**PLANNED UNIT DEVELOPMENT  
& SUBDIVISION STAFF REPORT**

**Date: November 1, 2007**

McMurray Place Subdivision

# SITE PLAN

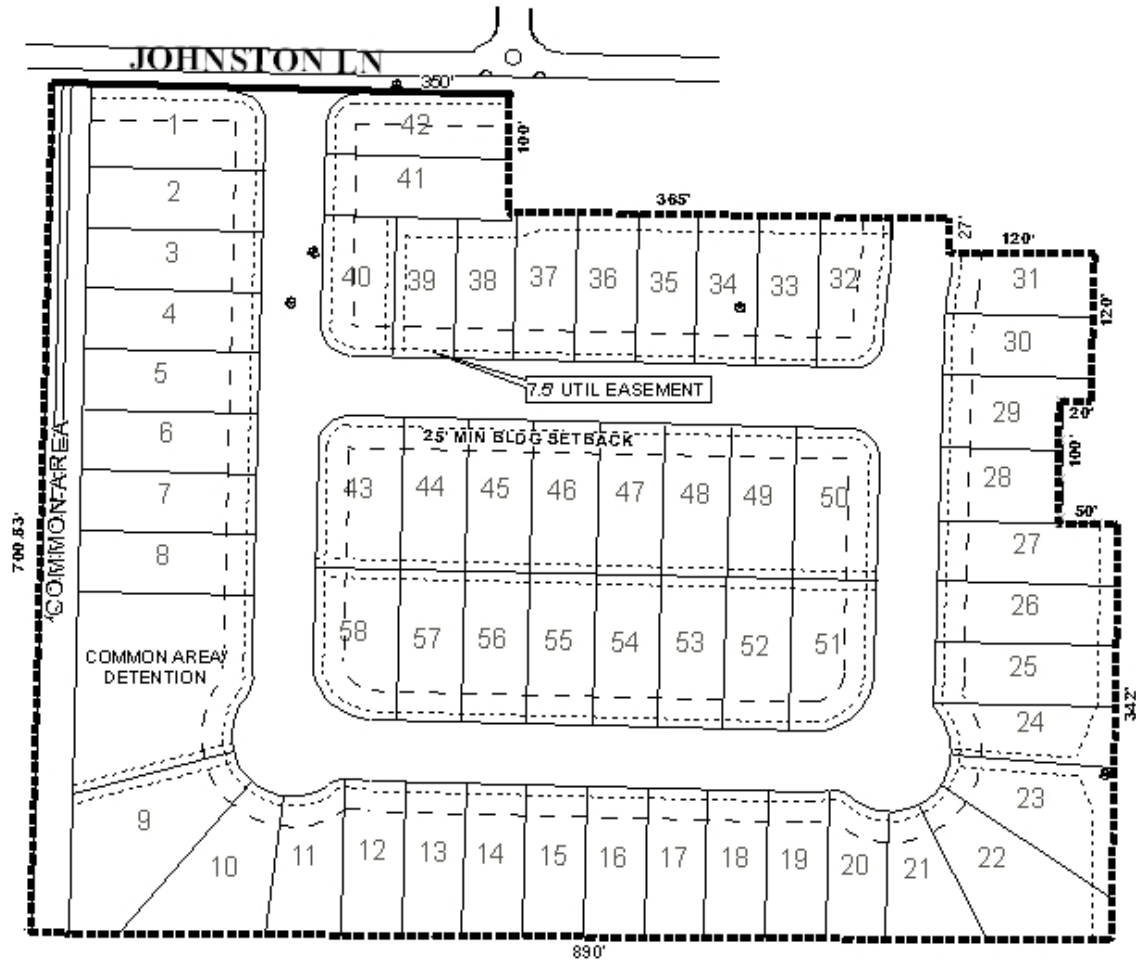
Regarding the proposed building setbacks, 25-feet is proposed for the front yard setback, while 20-feet is proposed as the street-side side yard setback for corner lots. Other side yard setbacks are proposed to be zero feet and 10-feet. The rear yard minimum setback would remain 8-feet. The PUD site plan depicts a 25-foot setback from all streets (except from Johnston Lane), while the Subdivision plat provides a note stating 25-foot setbacks, but does not depict any setbacks. Both the PUD site plan and Subdivision plat should be revised to depict, label and note the requested setbacks, especially regarding where the 20-foot side yard setback for corner lots is desired, and which side of each lot will be required to provide a minimum 10-foot side yard setback (with the other side yard setback being 0 feet). As a 20-foot side yard setback for corner lots is allowed by the Zoning Ordinance, but not by the Subdivision Regulations, the Subdivision Regulation requirements should be waived in favor of the requested setbacks. The corner lot side-yard setback should also be depicted from Johnston Lane.

As storm water detention will likely be required for the development, and as no information has been provided by the applicant regarding how storm water will be handled (detention pond versus in pipe storage), this application should be heldover to allow the applicant to address the storm water issues, and to revise the PUD site plan and Subdivision plat to depict setbacks. As a reminder, PUD approval is site plan specific, thus if a detention pond will be provided, the general location must be depicted and appropriately labeled (storm water detention common area) on the site plan and plat.

Finally, the site plan and plat depict an area of land behind proposed lots 32 and 33 that is not labeled as a lot or any other use. Aerial photographs from 2006 imply that the house fronting onto Schuab Avenue is using this area as well as the rest of area to the McCay Avenue right-of-way. If the depicted block of land is being sold to the adjacent single-family residence, then the residence should be included within the Subdivision application so that a new lot can be created.

*Revised drawings were provided by the applicant, depicting a reduced number of lots (58 instead of 61 lots), a new detention area of approximately 20,000 square feet, and inclusion of the vacated right-of-way on the West side of the site, as additional common area. The revisions reflect most, though not all of the requested changes to the drawings. As revised, 21 of the proposed 58 lots will meet the minimum lot area requirements (the smallest proposed lot will be 6,000 square feet), though it appears that most of the lots will be less than 60-feet in width.*

*The primary concern not addressed is the proposed side yard setbacks. The reduced setbacks (zero lot line, 10-foot other side yard setback, and 20-foot street side yard setback) are not depicted on the plat or site plans. Section V.D.3. of the Zoning Ordinance states that corner lots must have a minimum buildable width of at least 30 feet: proposed lots 40 and 42 appear to fall below this requirement, however, if the requested 20-foot street side yard setback had been depicted, each of these lots might meet the minimum buildable width requirements.*

*It appears that the legal description for all three applications is missing a 50-foot long segment description for the Northern boundary of proposed Lot 27.*

*The corner lots proposed along Johnston Lane should be denied direct access to Johnston Lane. A note should be placed on the site plan and plat stating that all lots are denied direct access to Johnston Lane, and each lot is limited to one curb-cut, with the size, design and location to be approved by Traffic Engineering, and conform to AASHTO standards.*

**Planned Unit Development:** *Based upon the revised site plan depicting a maximum of 58-lots, the application is recommended for Approval, subject to the following conditions:*

- 4) *Revision of the site plan and plat to ensure that all lots have a minimum buildable width of 30-feet, exclusive of required setbacks or proposed drainage easements;*

- 5) *Revision of the site plan and plat to clearly depict requested front (25 feet), side (zero, 10 feet, 20 feet street side) and rear (8 feet) setbacks, and placement of the same information as a note on the site plan;*

- 6) *Placement of a note on the site plan and plat indicating the requested maximum building site coverage (45%);*
- 7) *Placement of a note on the site plan and plat stating that all lots are denied direct access to Johnston Lane, and each lot is limited to one curb-cut, with the size, design and location to be approved by Traffic Engineering, and conform to AASHTO standards;*

- 8) *Placement of a note on the site plan and plat stating that the detention facility will be design to provide minimum detention for a 100-year storm with a 10 year release rate, per Engineering requirements;*

- 9) *Placement of a note on the site plan and plat stating that the maintenance of all common areas, including the detention common area, is the responsibility of the property owners;*

***Subdivision:*** *Based upon the revised plat depicting a maximum of 58-lots, and with a waiver of Section V.D.2. for the overall development, and Section V.D.9. for the street-side side yards for corner lots (in favor of 20 feet, as required by the Zoning Ordinance), the application is recommended for Tentative Approval, subject to the following conditions:*

- 3) *Revision of the site plan and plat to ensure that all lots have a minimum buildable width of 30-feet, exclusive of required setbacks or proposed drainage easements;*

- 4) *Revision of the site plan and plat to clearly depict requested front (25 feet), side (zero, 10 feet, 20 feet street side) and rear (8 feet) setbacks, and placement of the same information as a note on the site plan;*

- 5) *Placement of a note on the site plan and plat indicating the requested maximum building site coverage (45%);*
- 6) *Placement of a note on the site plan and plat stating that all lots are denied direct access to Johnston Lane, and each lot is limited to one curb-cut, with the size, design and location to be approved by Traffic Engineering, and conform to AASHTO standards;*

- 7) *Placement of a note on the site plan and plat stating that the detention facility will be design to provide minimum detention for a 100-year storm with a 10 year release rate, per Engineering requirements;*

- 8) *Placement of a note on the site plan and plat stating that the maintenance of all common areas, including the detention common area, is the responsibility of the property owners;*
